Exhibit P6
Corporations

CP1	Anadarko Petroleum Corporation
------------	---------------------------------------

RE: Notice of Availability of the Draft Environmental Impact Statement and Land-Use Plan Amendments for the Energy Gateway South Transmission Project in Wyoming, Colorado, and Utah, 79 Fed. Reg. 9916 (February 21, 2014)

MAP 3
Camp Timberlane
(Property No. 513-2495)

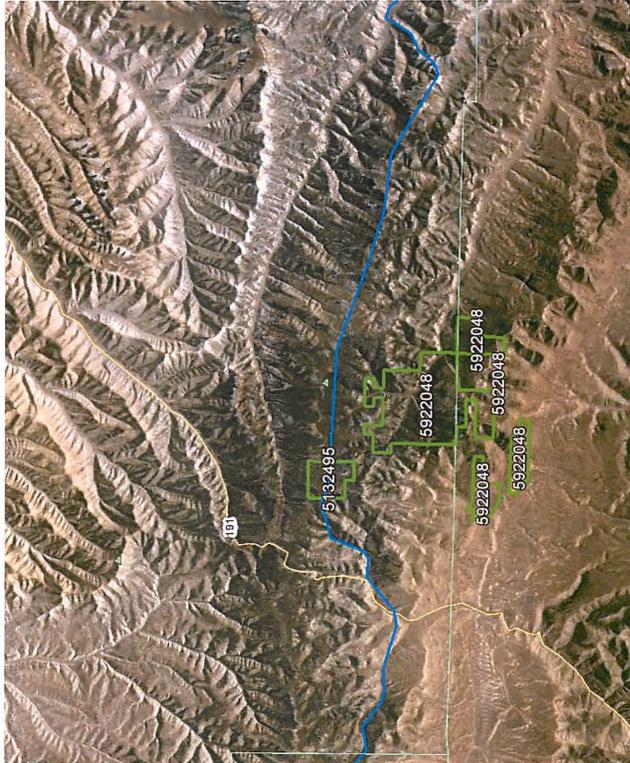
Camp Timberlane is a good example (see Maps 2 and 3). This is an existing camp that offers improvements and facilities for large groups of people. The Agency Preferred Route corridor bisects Camp Timberlane. The fact that the line may be located within the camp or very near to it is very concerning. A high voltage transmission line is starkly inconsistent with the purpose of a large camping complex frequented by large youth groups and families. Given the setting, the visual impact of the line would be jarring and would significantly degrade the value and purpose of the camp.

Regarding Camp Timberlane, when data were compiled, data received for the area indicated privately owned parcels and did not indicate existence of an organized recreational youth camp. Comments on the Draft EIS from the CPB informed the EIS team of the recreational use of the area. In response to this new information, representatives of the CPB, Applicant, and BLM met in April 2014 to discuss the CPB properties. Subsequently, the Applicant identified route variations in this area that would avoid Camp Timberlane while considering other existing and planned land uses in the area (e.g., seasonal-use homes) and sensitive environmental resources. These route variations have been analyzed for the Final EIS and are addressed in Appendix F.
